MCPB Item # 3/04/10

MEMORANDUM

Local Map Amendment G-884

RECOMMENDATION: Approval.

Master Plan Comparison

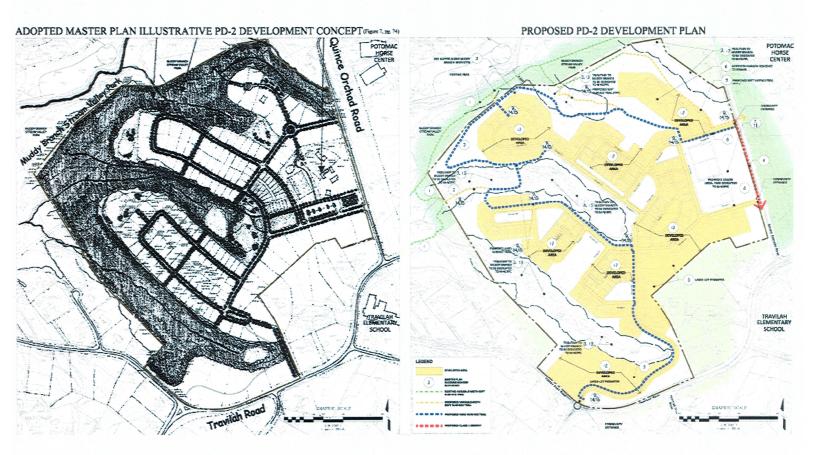
This development meets the Potomac Subregion general design principles. The proposed access road on Travilah deviates from the conceptual figure, but provides a better design solution by creating a roundabout with Turkey Foot Road, Travilah Road, and the site's entrance and avoids disrupting an existing stream.

In comparing the Potomac Subregion Master Plan recommendations and the proposed development plan, the proposal supports almost all of the Master Plan recommendations. While a slight deviation in road configuration from the Master Plan's conceptual layout is shown on the applicant's plans, this configuration is necessary as it avoids an adverse environmental impact to a stream on the property and an unworkable distance between two access points. Staff finds the proposed rezoning from RE-2 to PD-2 consistent with the 2002 *Potomac Subregion Master Plan*.²
